**RE: Mitchelton to Keperra Rail Line Duplication**

The “Arup Queensland Rail - Mitchelton to Keperra Duplication Environmental and Planning Study” dismissed the need to consider the impact that the rail duplication has on the community in a holistic way. It is not sufficient to look at the rail duplication in isolation, even if the rail corridor is deemed to be “community infrastructure” (Arup Feb 2006)

Figure 1. Brisbane International railway station and tracks superimposed over Dawson Parade at Grovely.

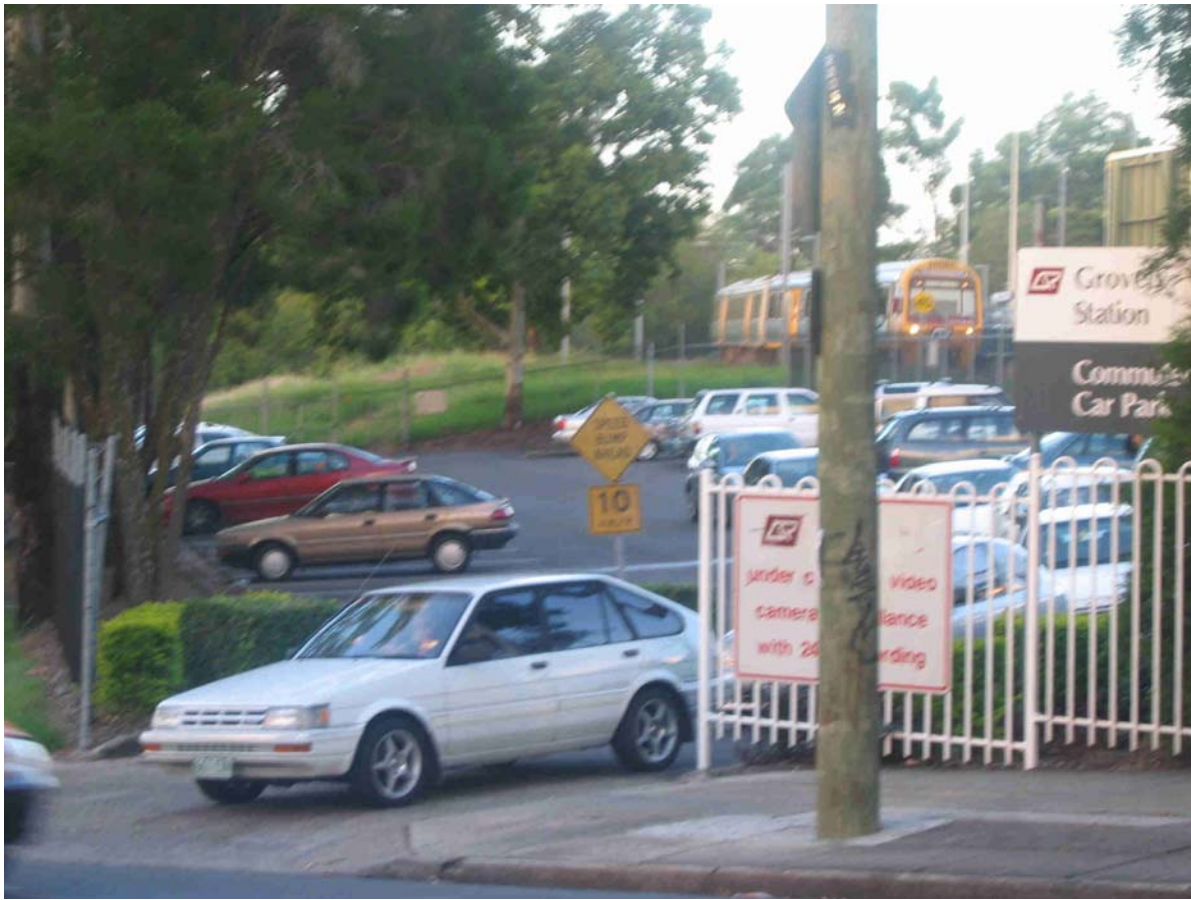
- Build a new Grovely railway station in the style of the Brisbane Airport International train station. That is a suburban sized station built over the top of Dawson Parade, so vehicular traffic flows under the station at roughly the same level it does now. See figure 1
